Town of Medway
DESIGN REVIEW COMMITTEE
155 Village Street, Medway MA 02053
(508) 533-3291

DRC Meeting Minutes: December 16, 2019
Medway Public Library

Preliminary Exterior Elevations
Job Number 1816
Date October 28, 2019
Drawn By DML
Revised Nov. 15, 2019

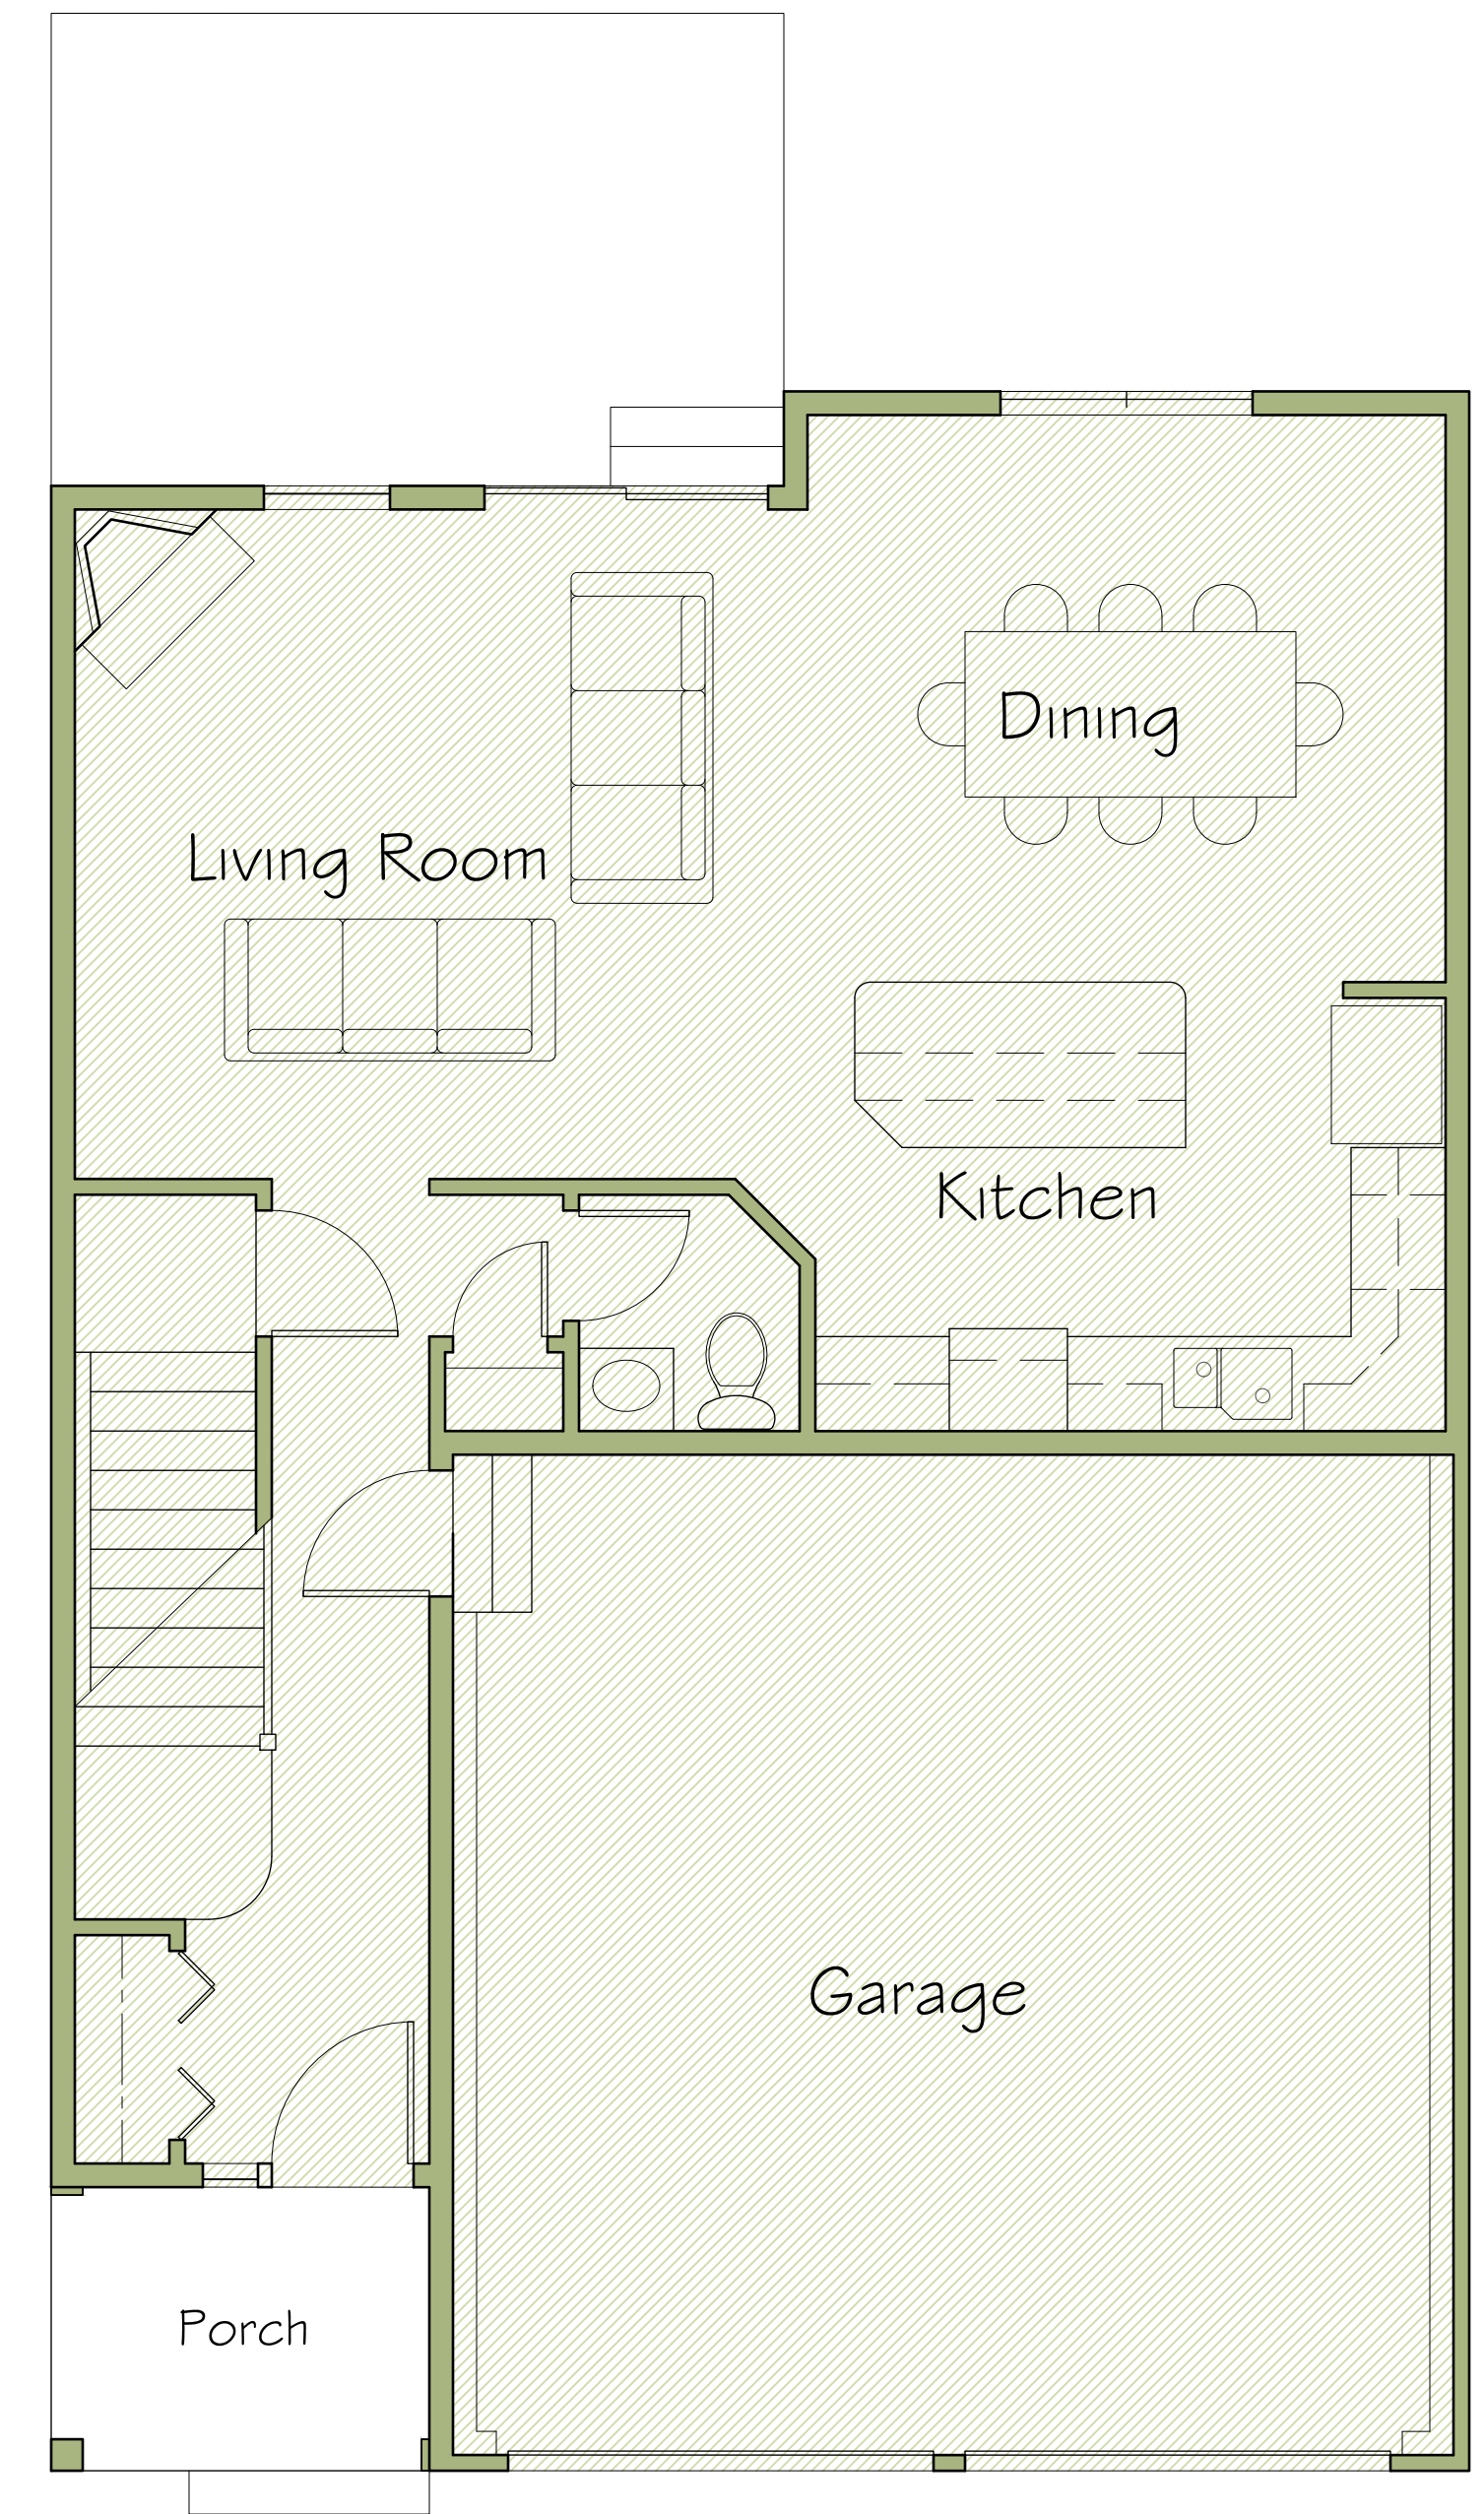
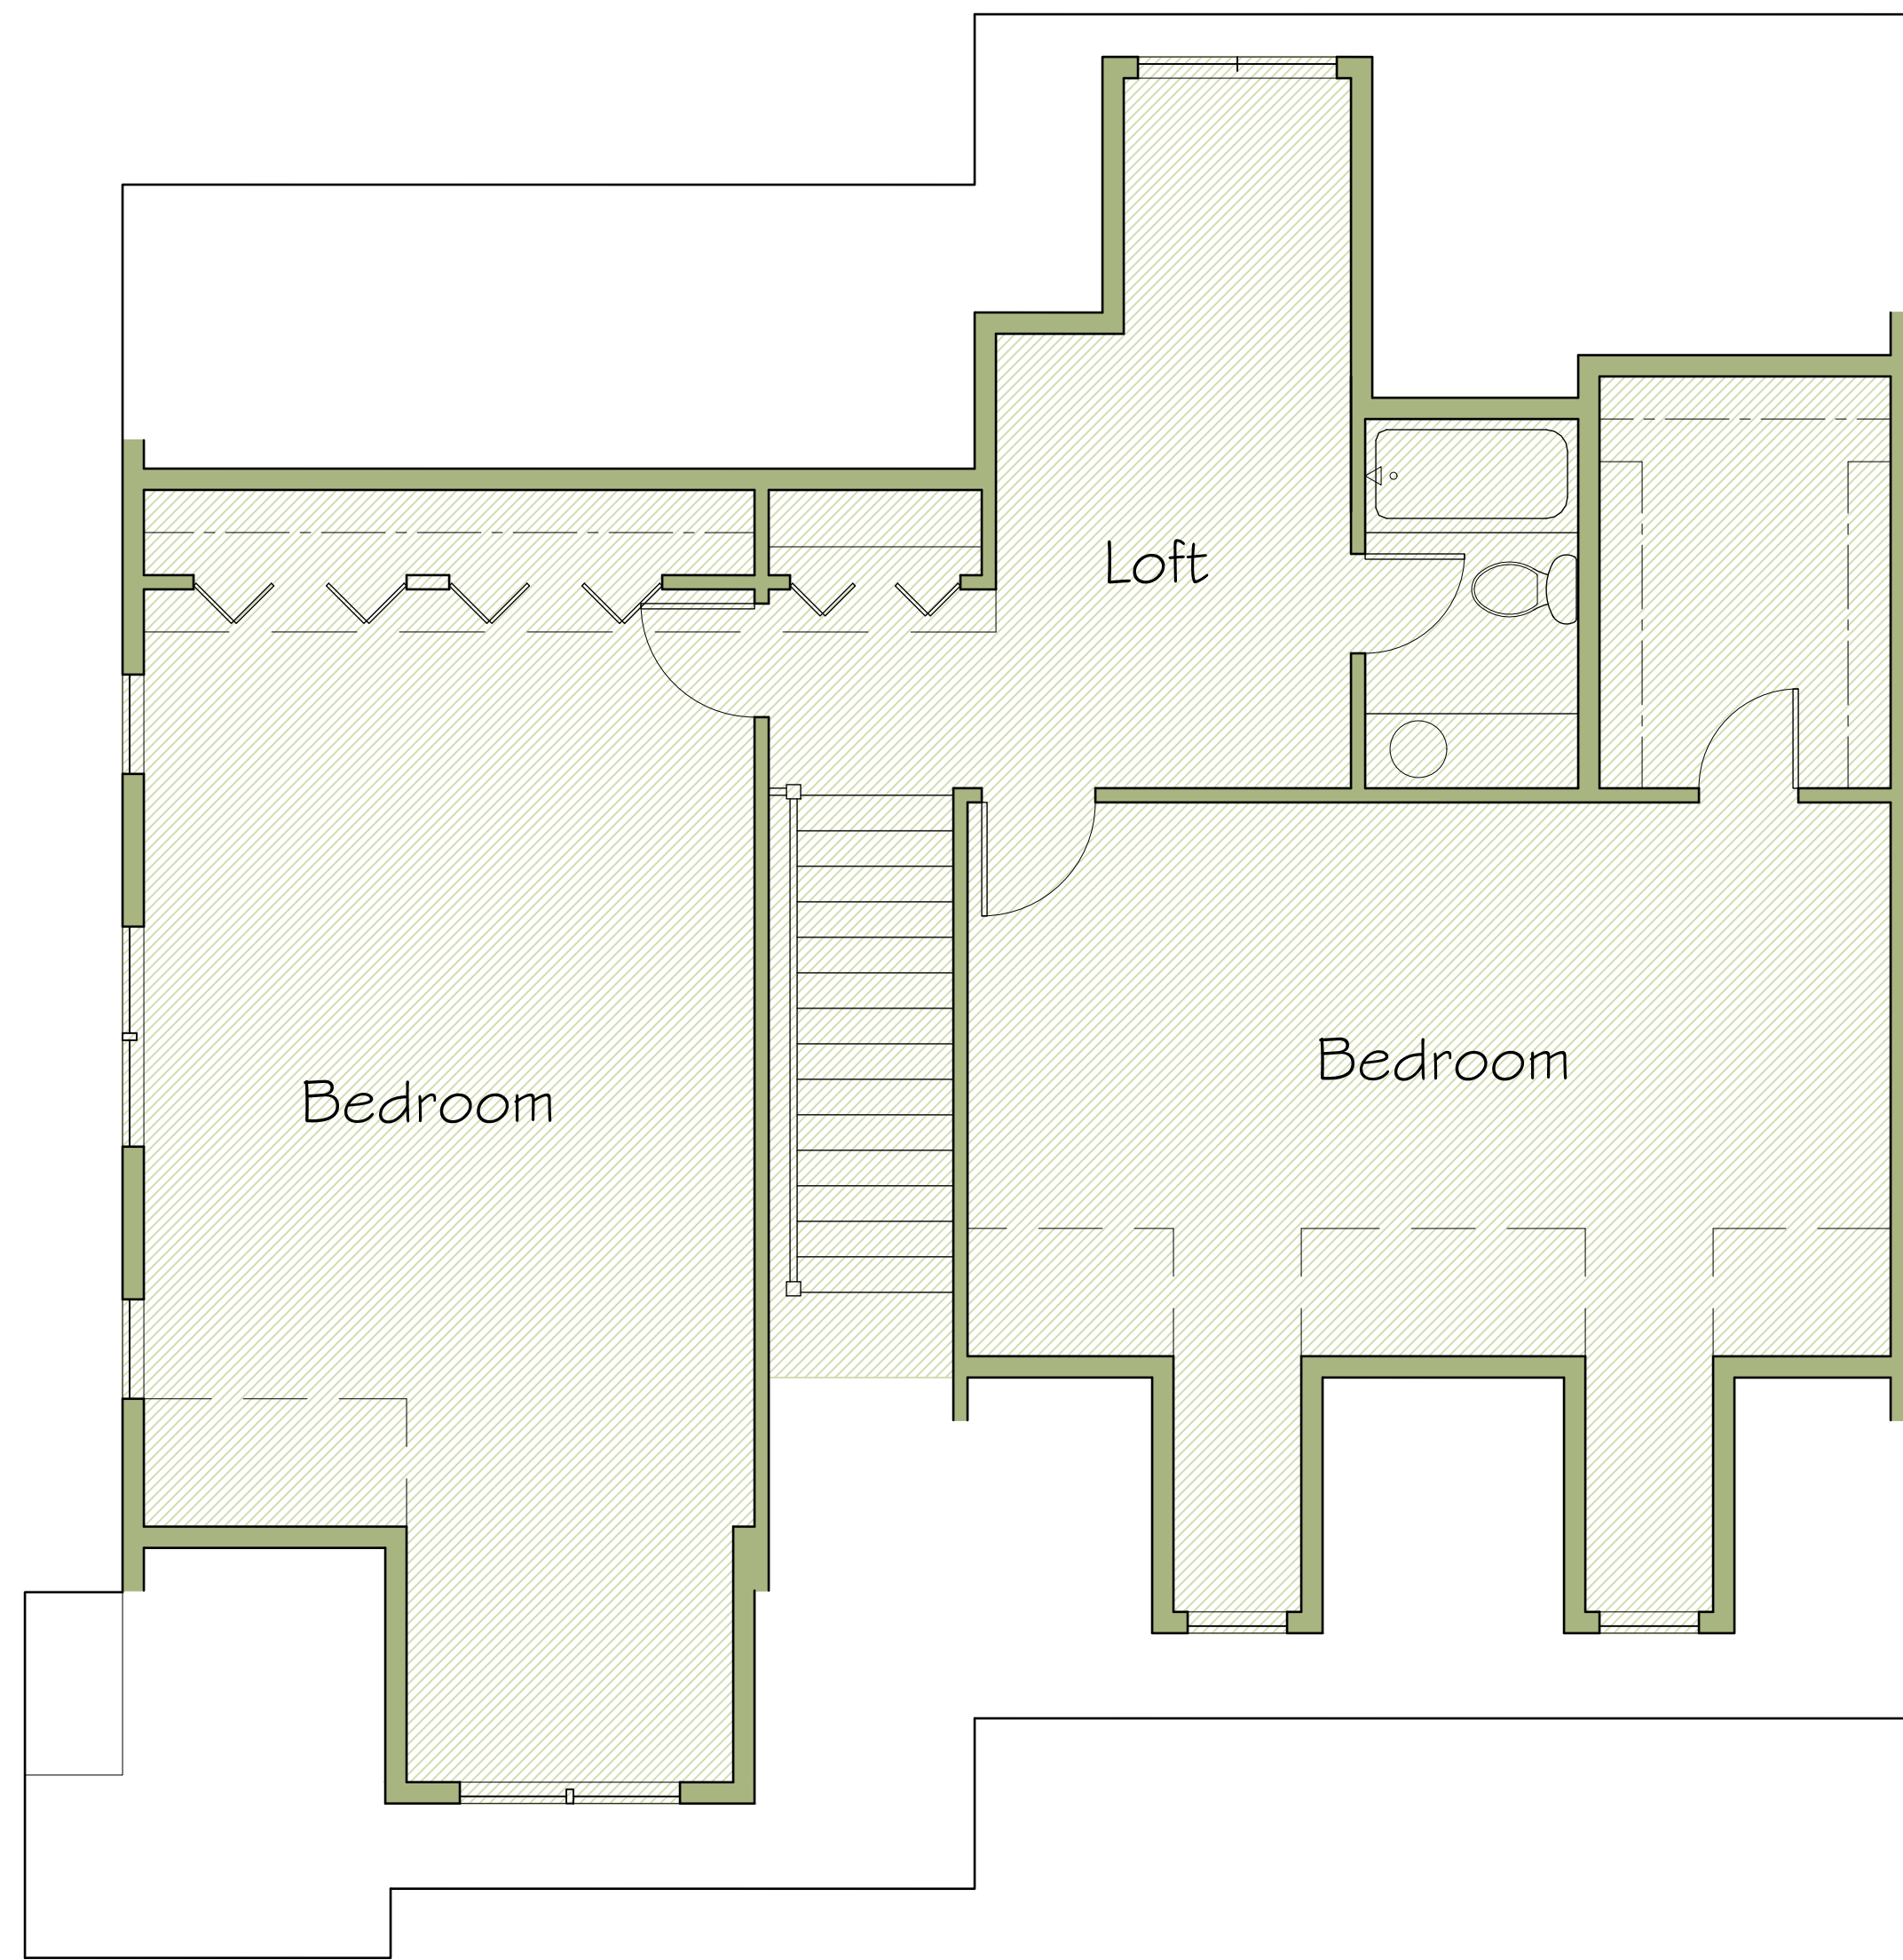
- Ms. Varrichione attended the meeting to discuss the item. The revised plan was submitted to the committee. **(See Attached)**
- Members liked the shingle details with the shown dimensions to the roof line. Dark charcoal grey siding will be used. The fence will be installed on the west side of the property and will go past the end unit in the back.
- The project will be presented at the Planning Board meeting on January 28th and at CONCOM on January 9th. Ms. Chabot will prepare the DRC's review letter.

Here they are per the DRB requests except for one thing. They had asked for one of the units in the four unit building to be flipped, but when I looked at it further, it didn't make sense. If unit 4 is the unit towards the street, when you flip unit 6, there are still garage doors beside each other. The front doors are all separated from each other either way. But when I looked at the site plan, the original configuration is best. First of all, I'd rather have the garage doors on the high side where possible. The grading is better that way, Whenever the garage doors are on the low side, the grade has to drop more suddenly at the adjacent unit. Plus, the garage doors that are side by side are offset, front to back, and if I flip Unit 6, the garage doors almost align.

As mentioned, I did not change the column size on the color rendering, but I have changed them on the black and white. Please let me know if you need anything else.
